## **TRAFFIC IMPACT STUDY REVIEW COMMENTS**

**Project:** Traffic Access Study of Carr Farms TIS  
**Date:** 7/24/2018  
**Review Type:** Traffic Impact Study Review  
**Designer:** EMH&T  
**Reviewer:** Scott Seaman, PE (GPD), Kevin Moderie, PE (GPD);  
Letty Schamp, PE (Hilliard)

TRAIL  
CONNECTIVITY  
PLAN

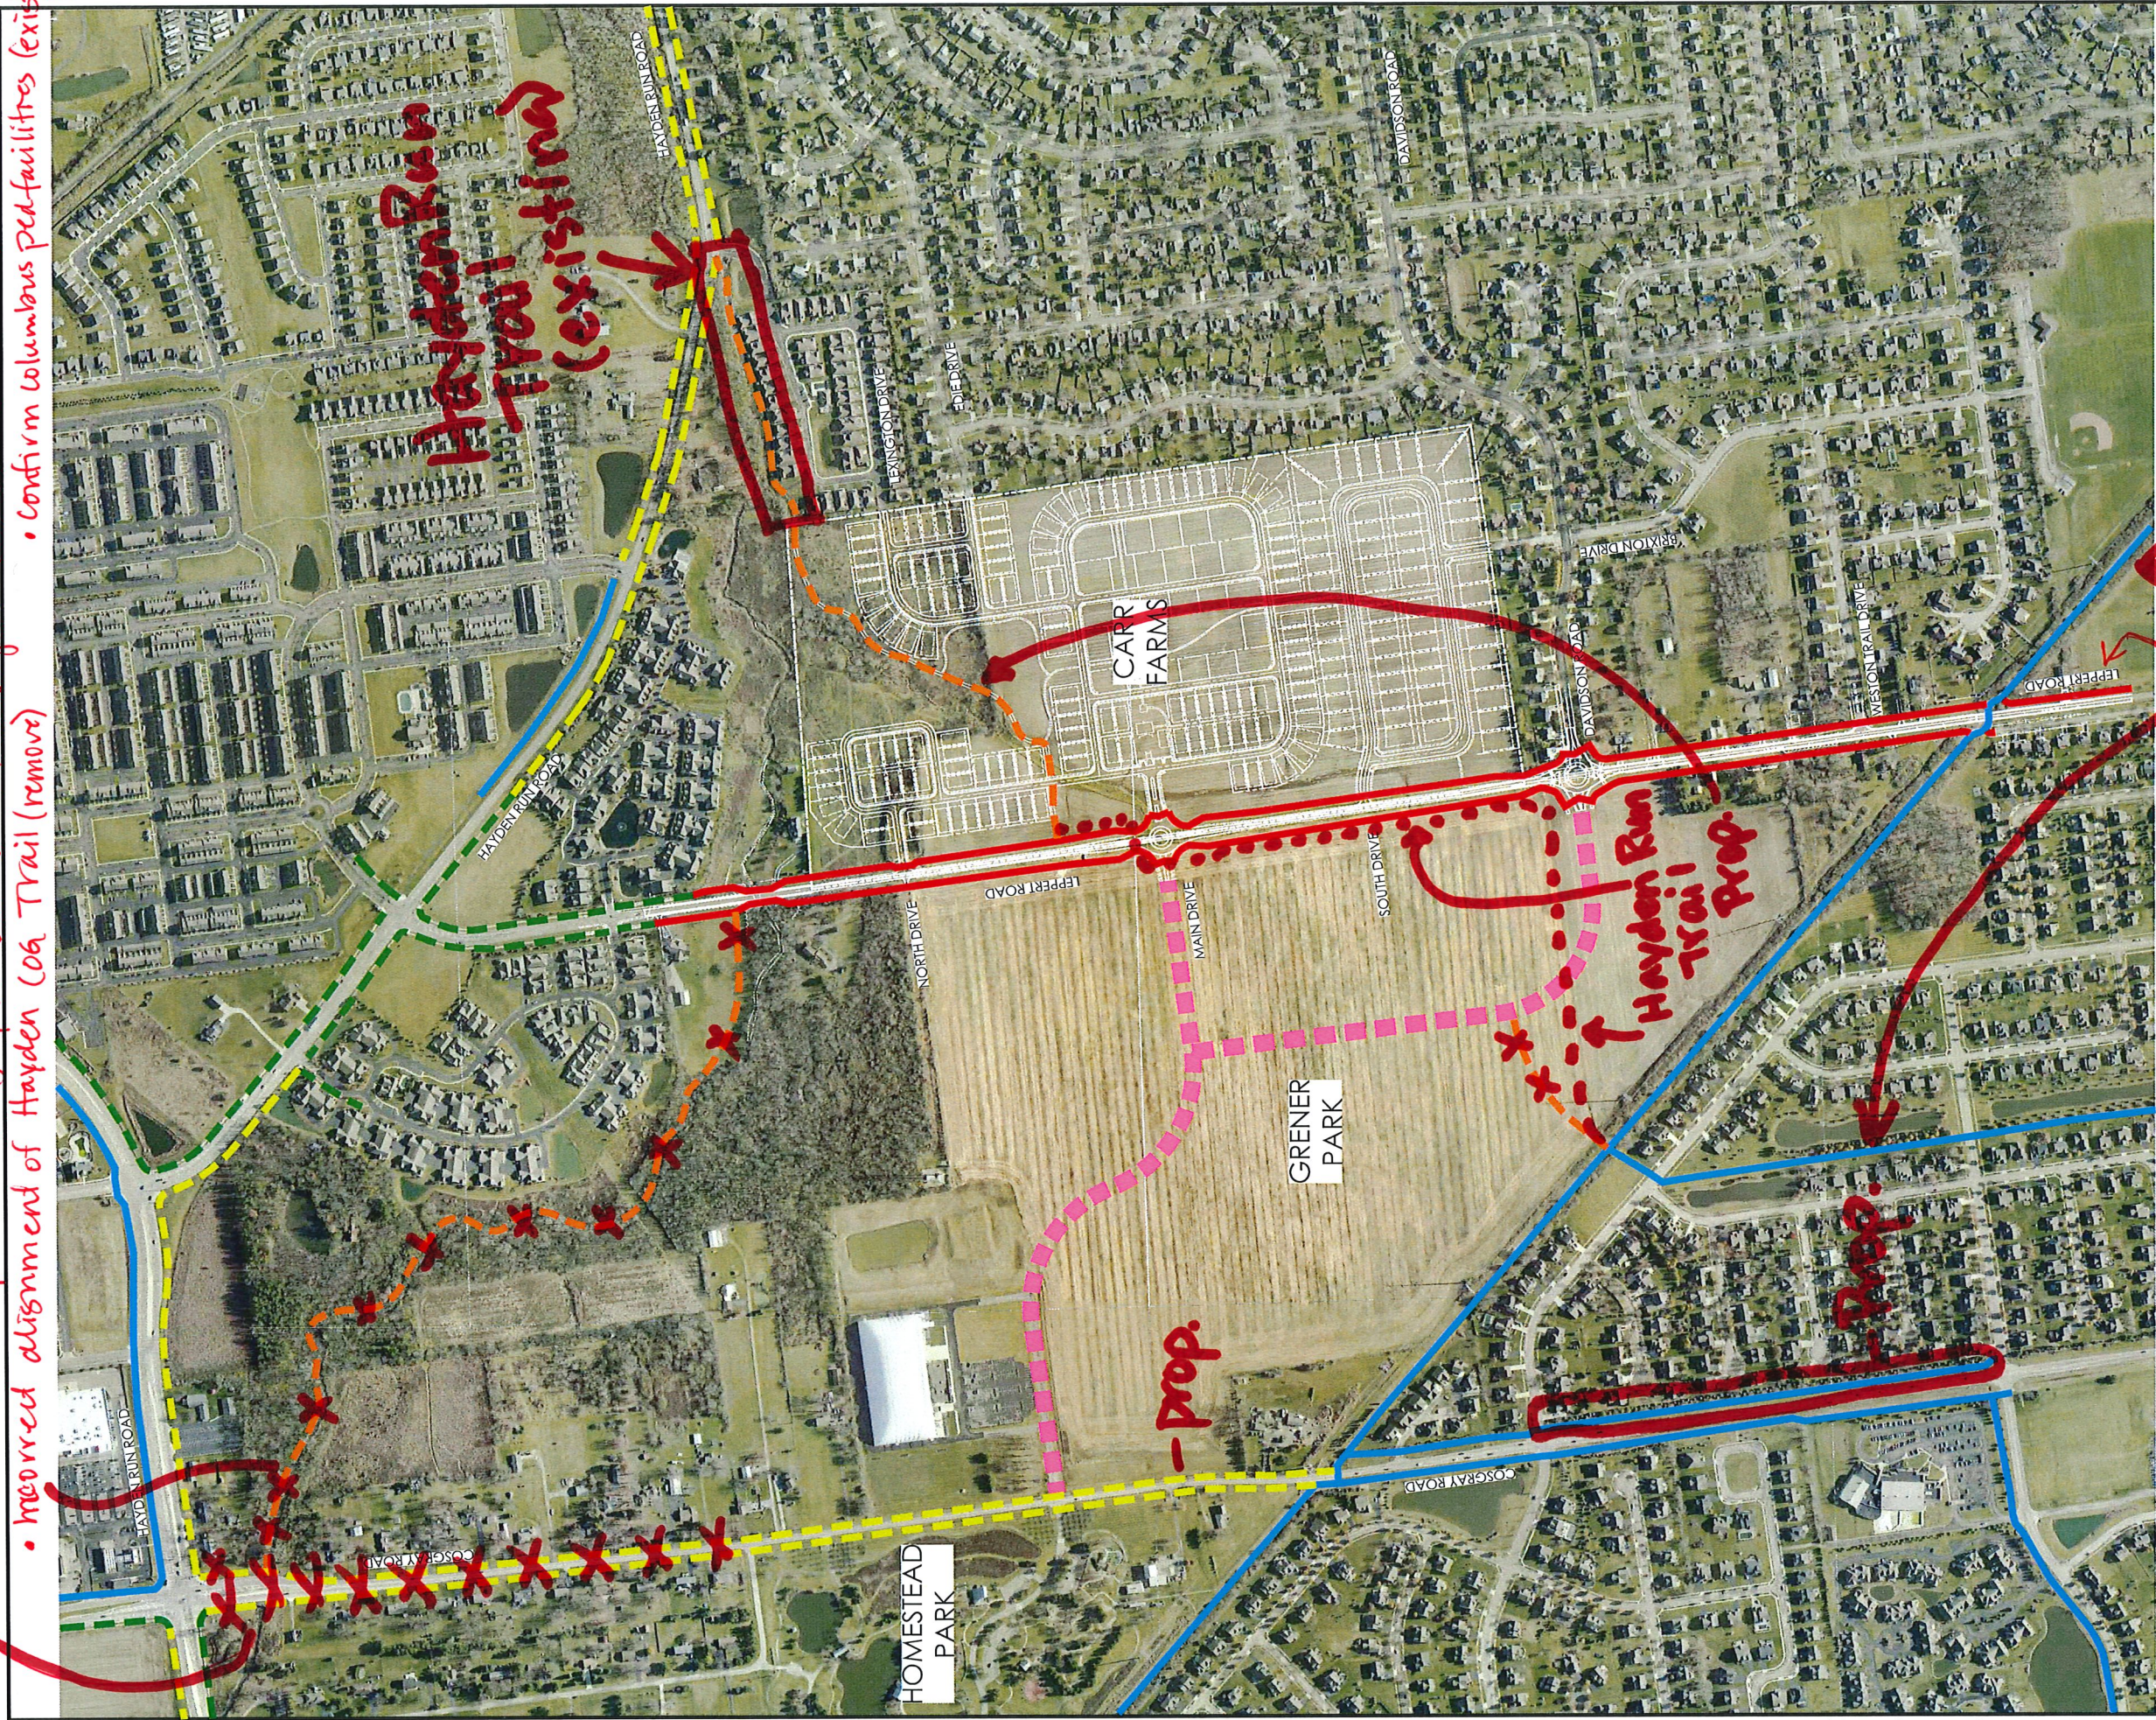
14. Update the Trail Connectivity Plan Exhibit showing the Hayden Run COG Trail connecting to the Heritage Trail via the Greener Park as per the attached marked up exhibit.

Do not show future paths on Cosgray Rd outside Hilliard jurisdiction (north of Baldwin)  
• confirm columbus ped facilities (existing prop)

• Show Existing as Solid & Proposed as dashed

• Clearly identify COG Trails (Hayden Run Trail & Heritage Rail Trail & Hellbranch Trail)

• COG trails need to be differentiated from MUPs along streets

• Show roads through Greener Park based on current layout (schematic only)
